Subject: AP1000 COL Response to Request for Additional Information (TR #44)

Responses to Request for Additional Information on Technical Report No. 44

RAI Response Number: RAI-TR44-01

Figure 44-2.1 Stress Strain Curve for SA240-304 Stainless Steel

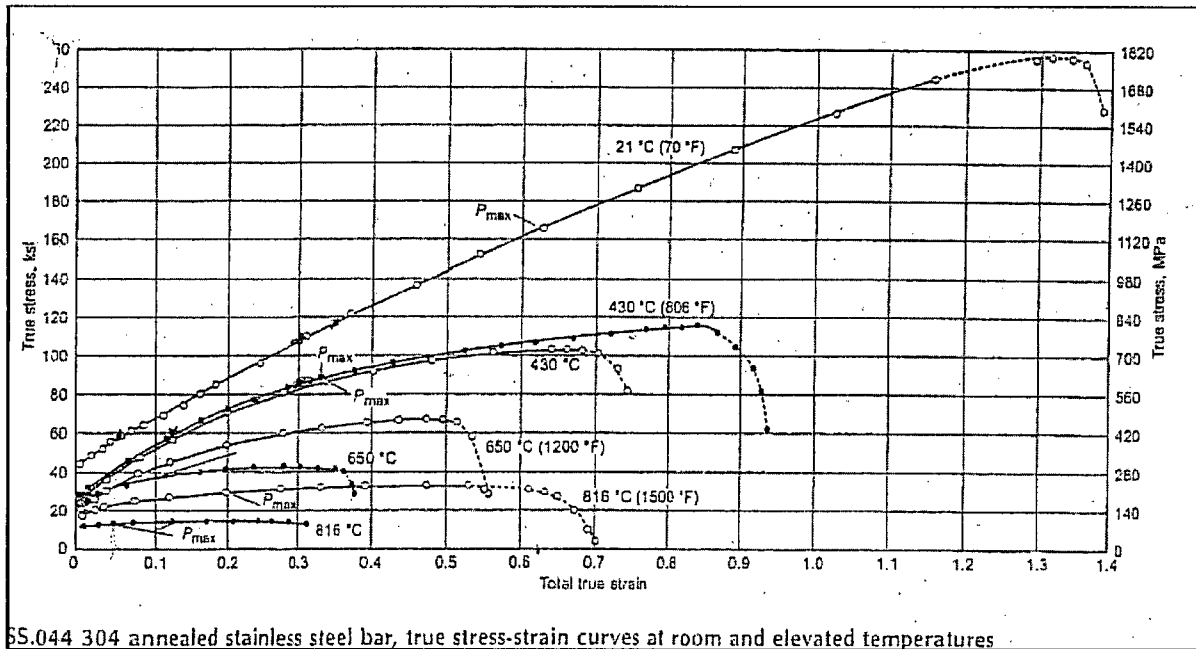
Section 2.8.5 states that appropriate non-linear material properties have been applied to the rack components to permit yielding and permanent deformation. Table 2-6 only provides Young's modulus, yield strength, and ultimate strength, which are not sufficient to define an engineering stress-strain curve. In addition, LYDYNA requires true stress-strain relation for its nonlinear materials. Therefore, provide the following: (1) a complete description of the material stress-strain curve and confirm that a true stress-strain curve was used in these impact analyses and (2) a description of the fuel assembly model, including the element properties and material properties for the dropped fuel assembly.

1) The new fuel racks are fabricated from SA240-304 and SA564-630 stainless steel. For the impact analyses, a true-stress strain curve, which is obtained from Atlas of Stress Strain Curves (2nd Edition, ASM International) and reproduced below as Figure TR44-2.1, is used to define the strength properties of SA240-304 stainless steel.
